Southold Town Board of Trustees Field Inspection Report

L.K. McLean Associates on behalf of **AWC DOCKSIDE, LLC** requests a Wetland Permit for Marina improvements consisting of the as-built 6'x98', 6'x218' and 6'x12.10' ($\pm 1,988$ sq.ft.) sections of CCA decking along top of existing southerly bulkhead section; within a 10' wide area in front of existing bulkhead section incidentally dredge ± 140 cubic yards over $\pm 1,600$ sq.ft. area to a max. depth of 6' below Mean Low Water (EL. -8.86) to reclaim soil lost from behind existing deteriorated bulkhead; excavate $\pm 2,015$ cubic yards of material over an area of 4,030sq.ft. between existing and proposed bulkheading to elevation -8.86 max (6' below Mean Low Water) with unsuitable material to be removed from site; remove ± 160 linear feet of existing bulkhead and install new ± 161 linear feet of vinyl bulkhead varying $\pm 15'$ to $\pm 32'$ landward of existing bulkhead location and $\pm 1.8'$ higher than existing bulkhead; install a 22.3' north vinyl return and a 14' south vinyl return; construct a 26' long vinyl slotted breakwater off north end of bulkhead; create nine (9) 15'x35' slips by installing 10 new mooring piles and

SECTION B-B
REPLACE TIMBER DECKING (1,960 SF)

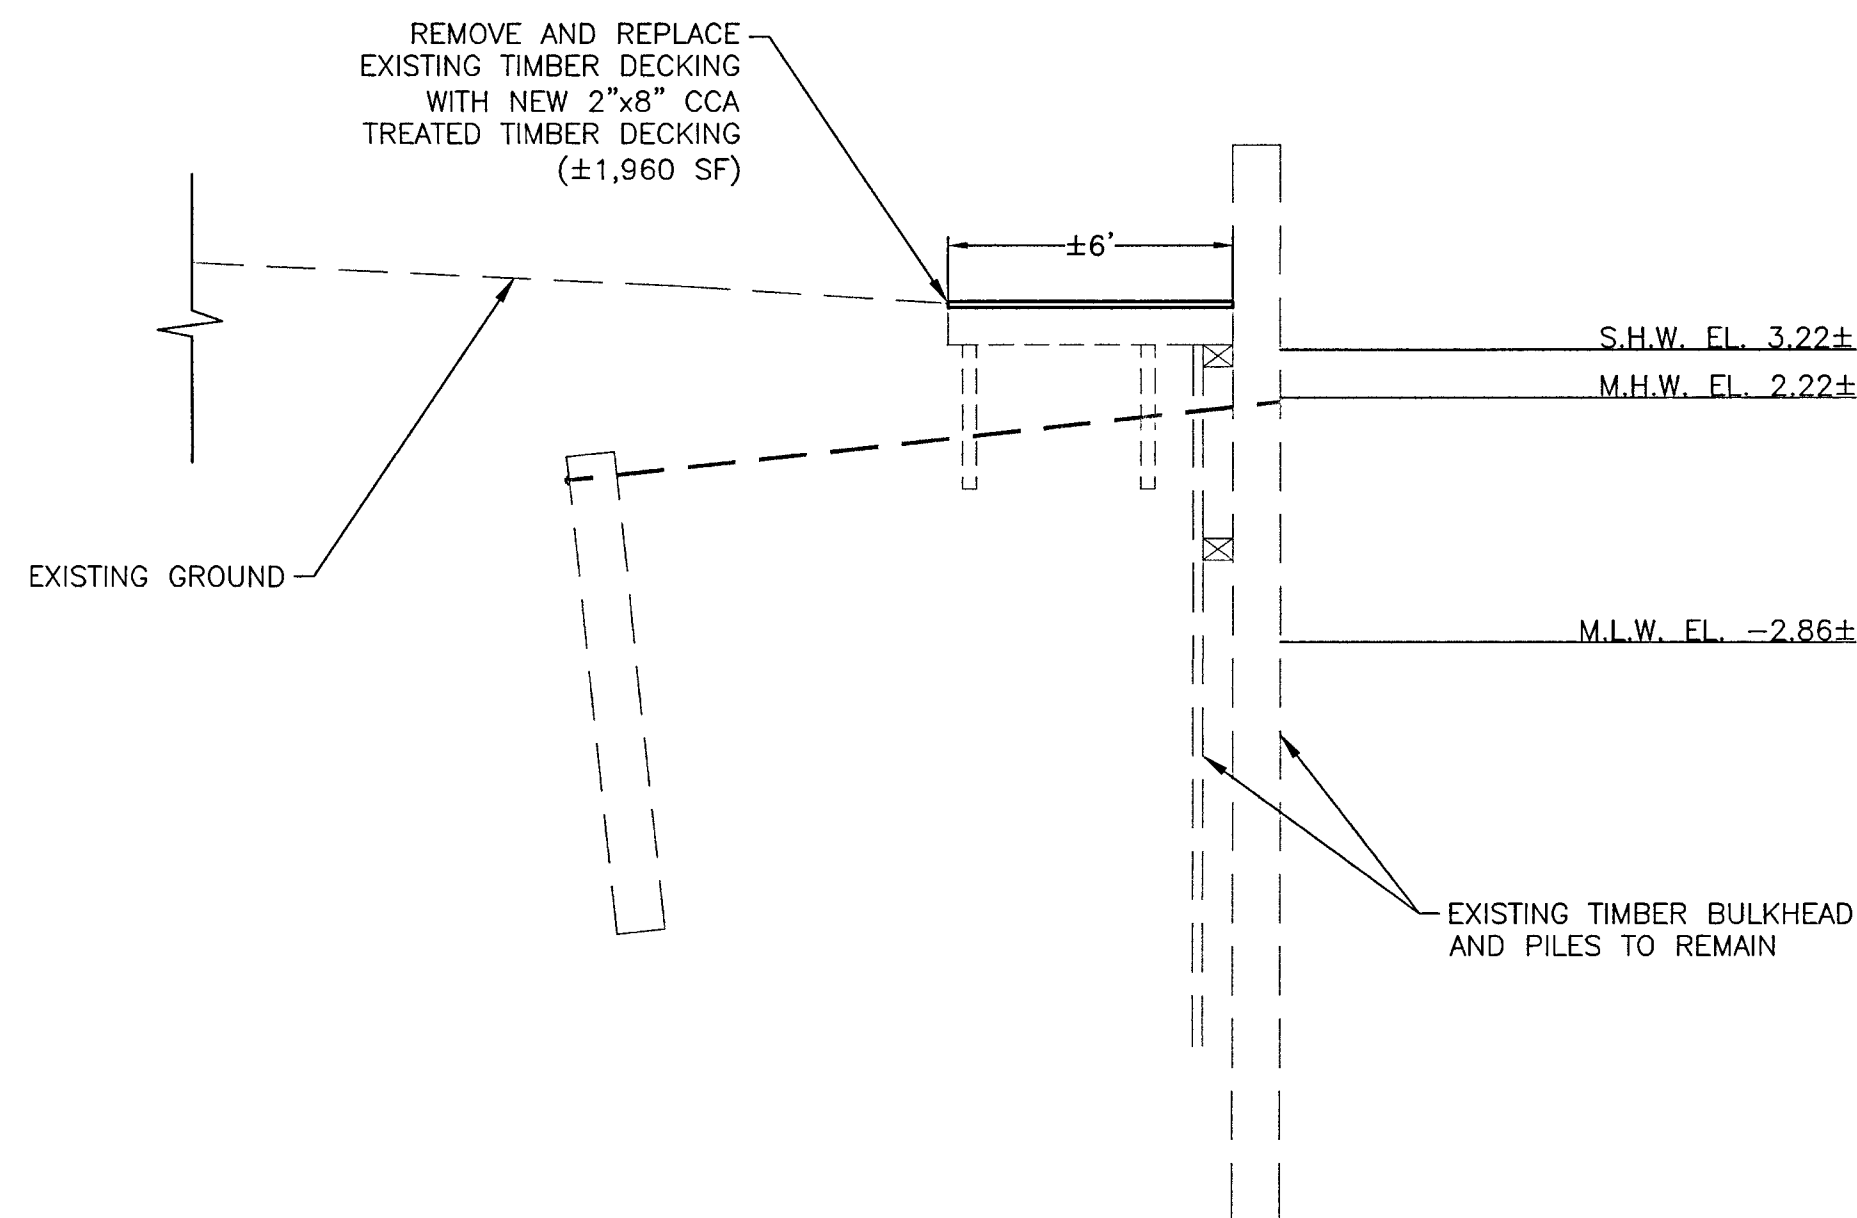
- 1. The structures were constructed without a Chapter 275 Wetlands Permit.**
- 2. The as-built includes 1960 SF of CCA-treated decking.**
- 3. What is the composition of the dredge spoil used on-site?**
- 4. The number and size of vessels that could be moored are not shown.**
